**Pier 26 Upland Park Construction – General Construction  
Project/Contract #C4891-A  
Addendum # 4  
December 3, 2018**

**(A) "1. C4891 –A-E Pier 26 Upland Park Construction" is amended to include the following drawing modifications:**

**AMENDED ATTACHMENT A DOCUMENTS**

**L-210.00**

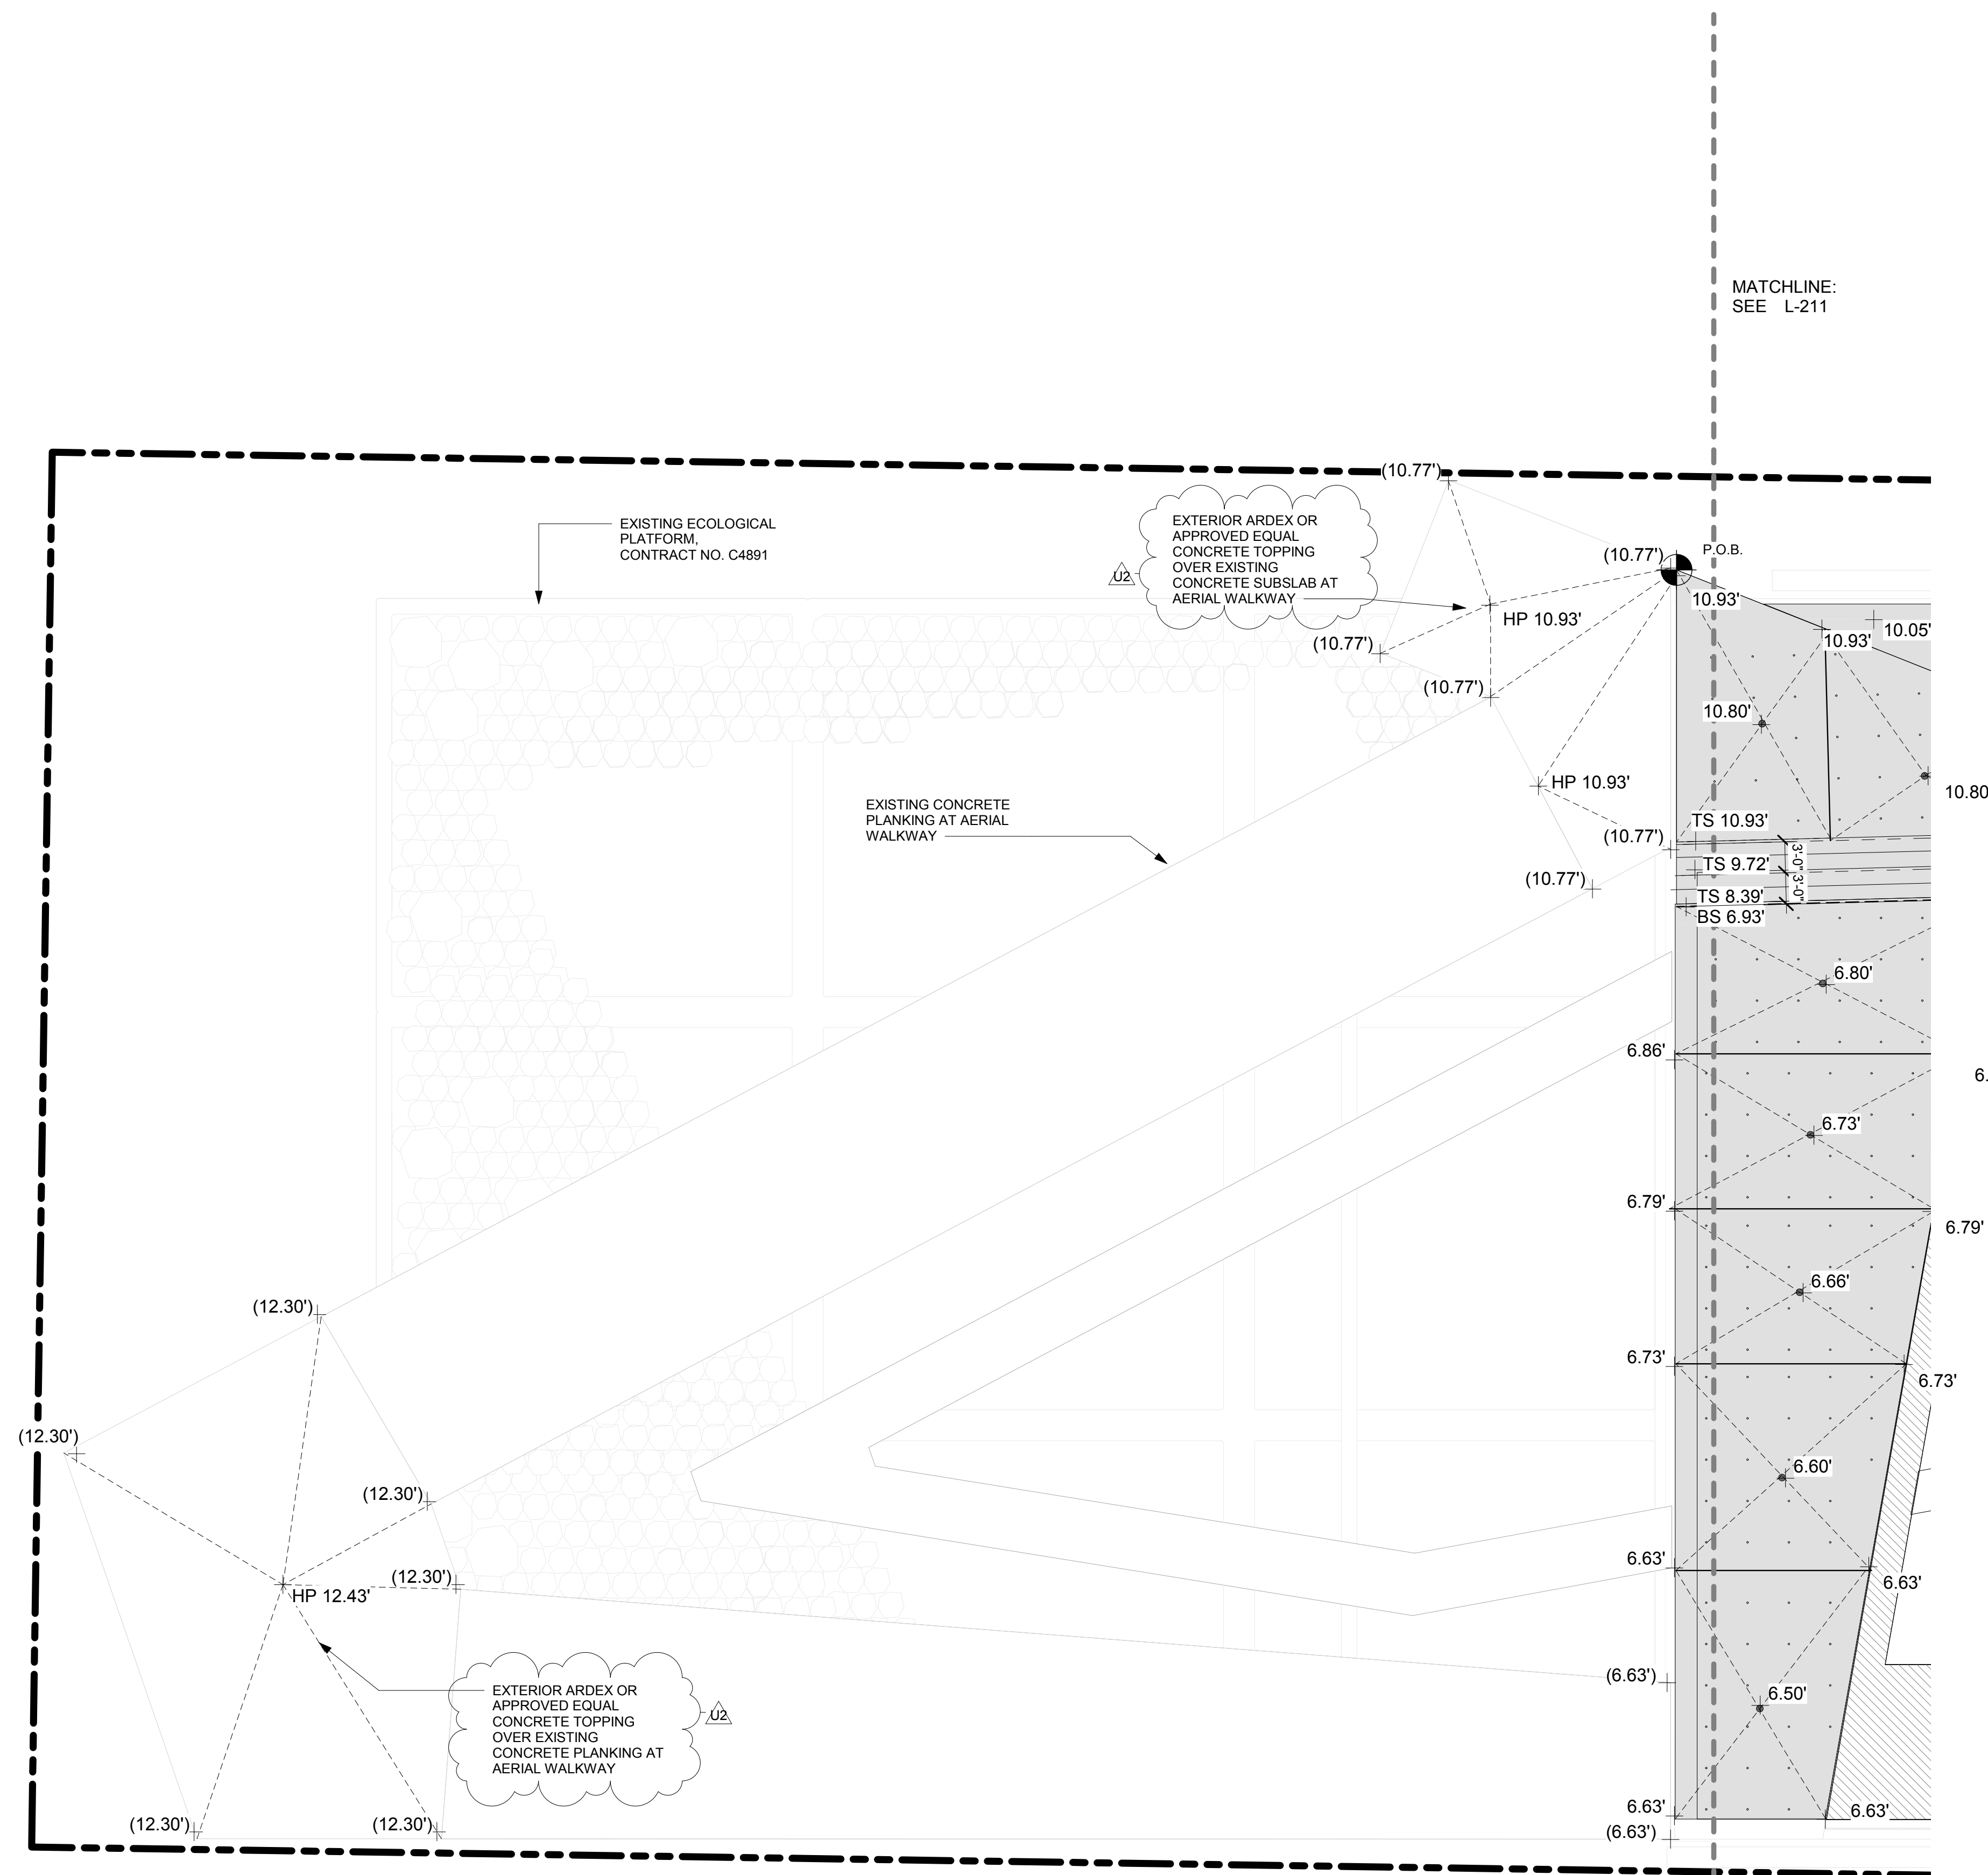
<b>Drawing</b>	<b>Update</b>
L-210-DECK SUBSLAB LAYOUT&GRADING PLAN - PIER A	Topping slab description clarified.
L-230-PAVING& DECKING PLAN- PIER A	Legend corrected to say inlaid finish, instead of sandblast inlaid finish.
L-231 - PAVING & DECKING PLAN - PIER B	Legend corrected to say inlaid finish, instead of sandblast inlaid finish.
L-232 - PAVING & DECKING PLAN - PIER C	Legend corrected to say inlaid finish, instead of sandblast inlaid finish.
L-233 - PAVING & DECKING PLAN - PIER D	Legend corrected to say inlaid finish, instead of sandblast inlaid finish.
L-234 - PAVING & DECKING PLAN - NORTH UPLAND	Legend corrected to say inlaid finish, instead of sandblast inlaid finish.
L-243 - PAVING MODULES	The unique shell inlay material has been removed.
L-400 - GRADING PLAN - PIER A	Symbol for slot drain and trench drain has increased visibility.
L-401 - GRADING PLAN - PIER B	Symbol for slot drain and trench drain has increased visibility.

L-402.00

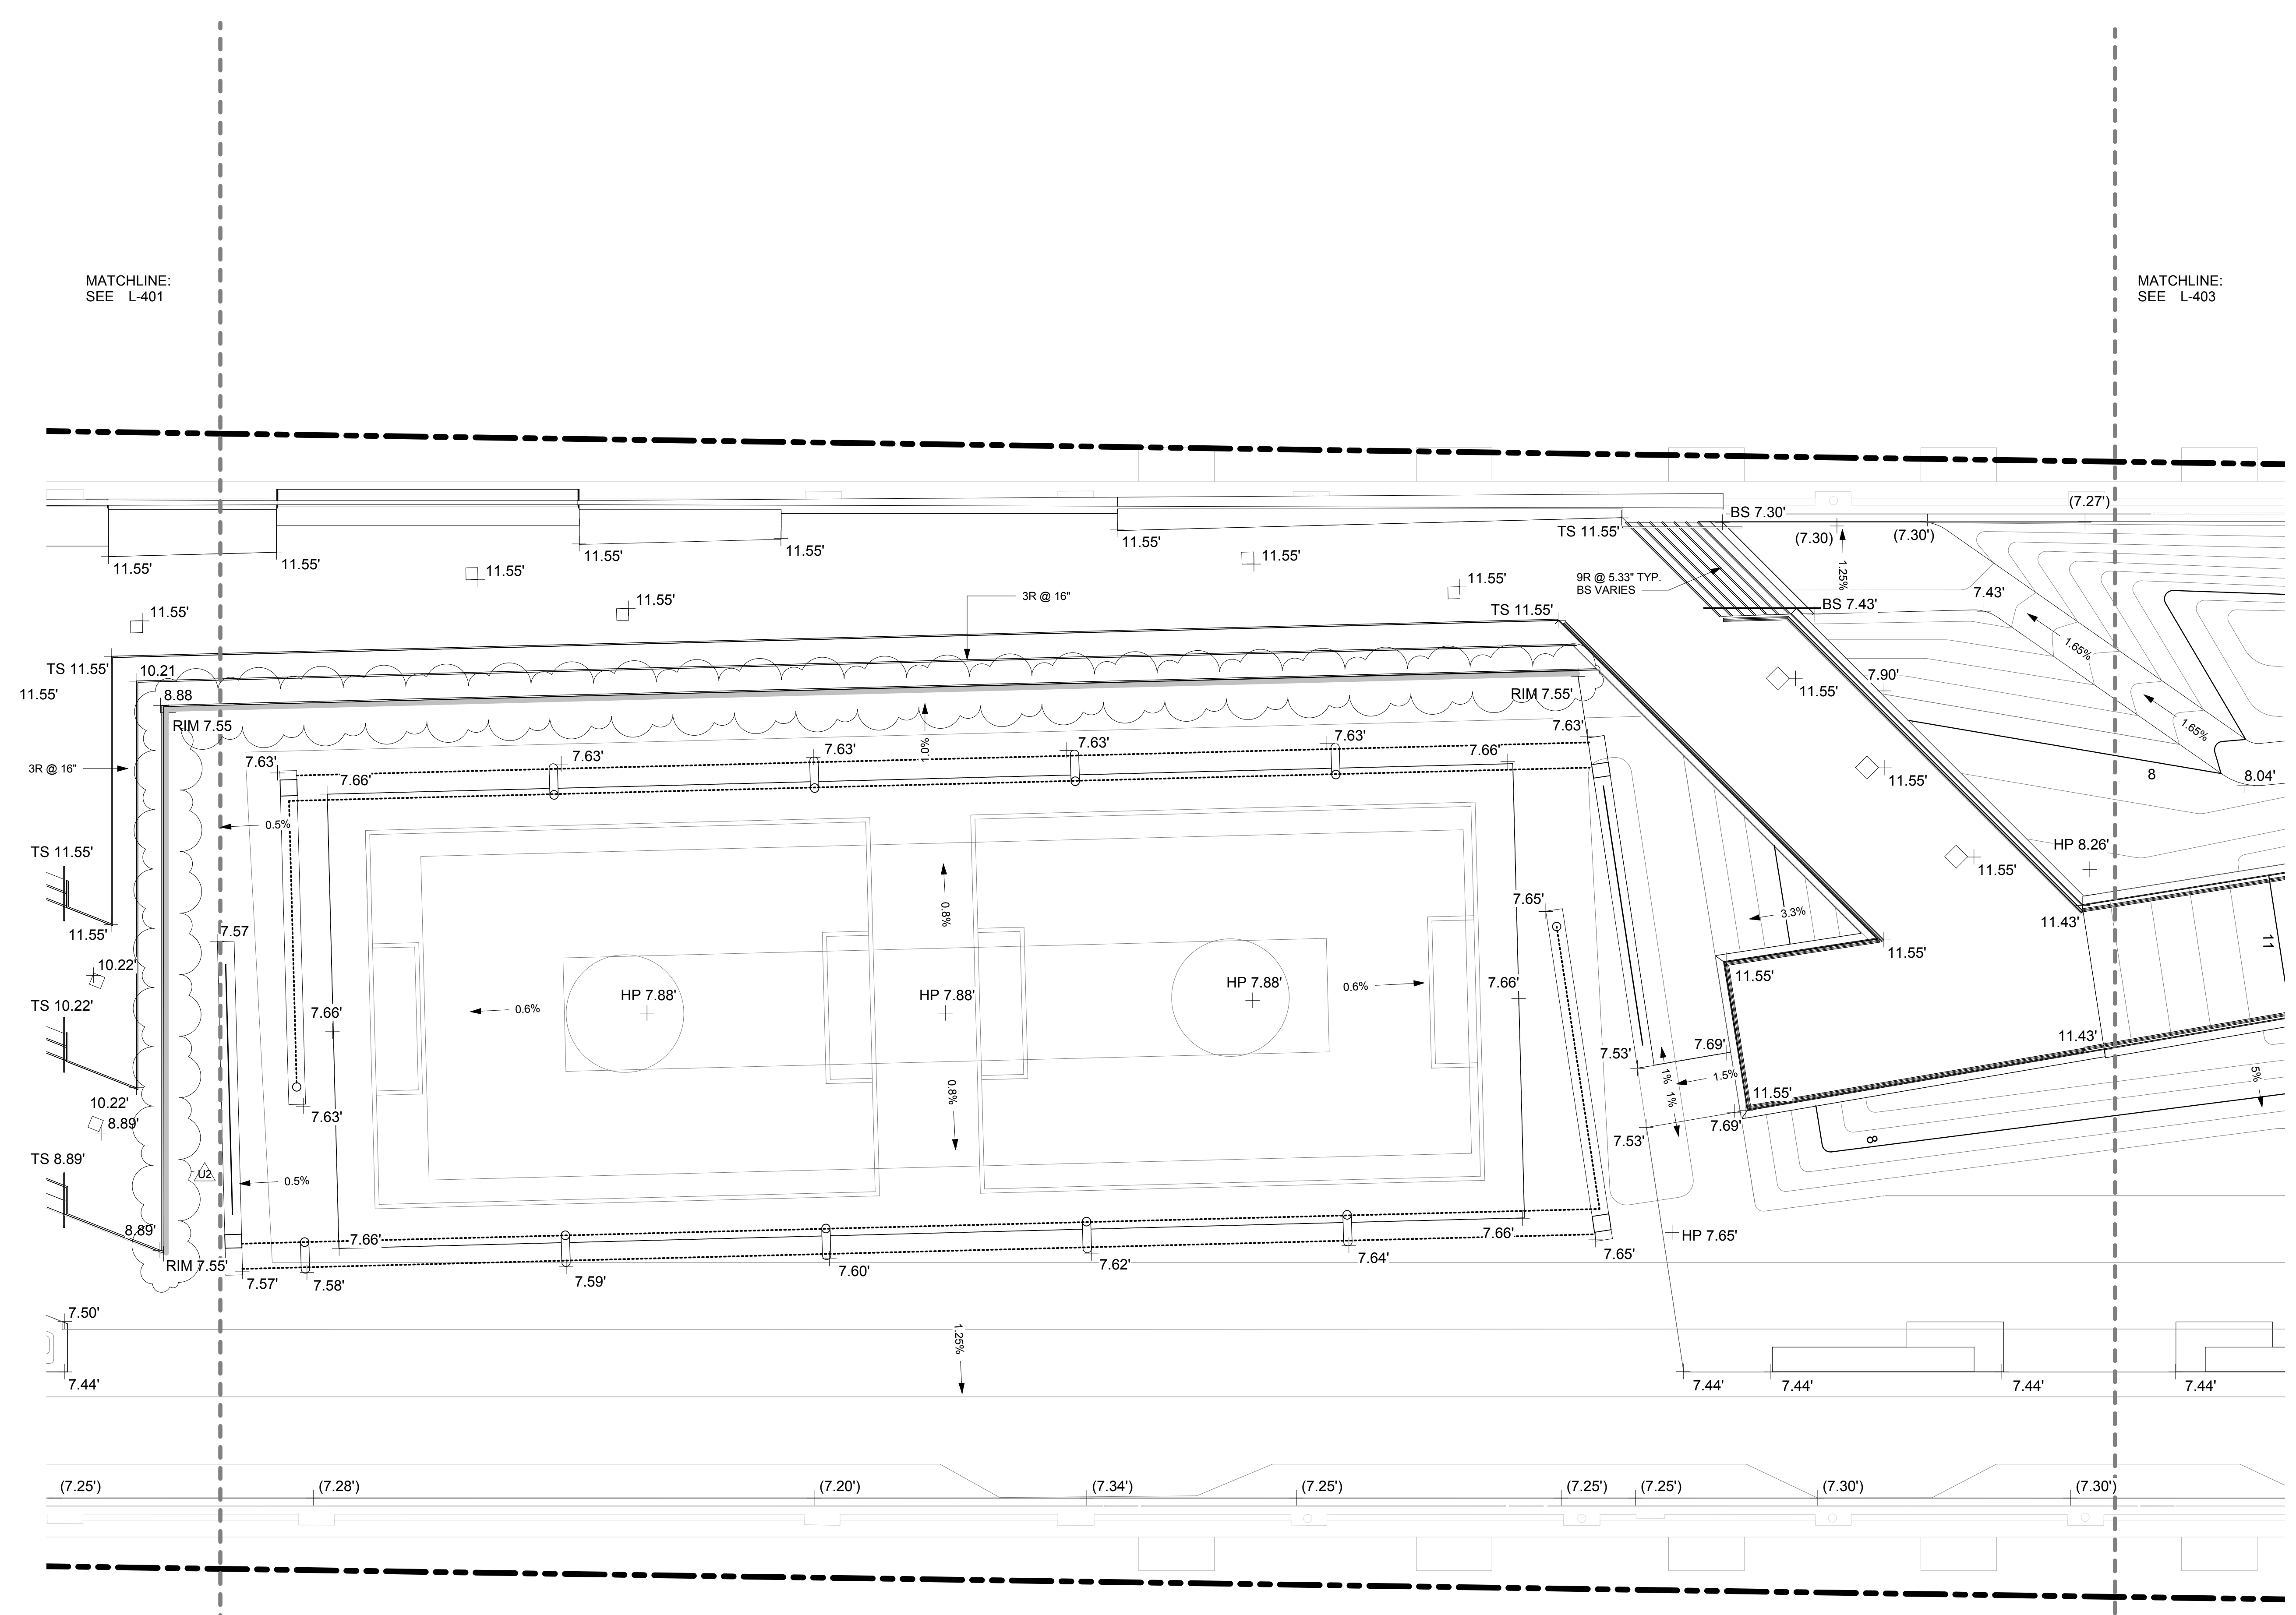
L-402 - GRADING PLAN - PIER C	Symbol for slot drain and trench drain has increased visibility.
L-403 - GRADING PLAN - PIER D	Symbol for slot drain and trench drain has increased visibility.
L-404 - GRADING PLAN - NORTH UPLAND	Symbol for slot drain and trench drain has increased visibility.
S-301 - FRAMING PLAN - PIER B	Walkway south of seating terrace no longer called out as 8" concrete seating step.
S-302 - FRAMING PLAN - PIER C	The thickness of the concrete is correctly labeled to show the 8" depth only at the 15' wide southern, as in the materials plans.
E-301 - ELECTRICAL PLAN - PIER B	Location of Q-vault shown.
E-302-ELECTRICAL PLAN - PIER C	Electrical clarification to sport pole.
E-308 - WOOD AND STEEL SHED ELECTRICAL DETAILS.pdf	New sheet showing clarifications of electrical work at the sheds.
P-303 - SANITARY PIPING PLAN - PIER D	Cross section of piping added.
P-312 - SANITARY PIPING PLAN - PIER C	Clarification to boat service utilities.
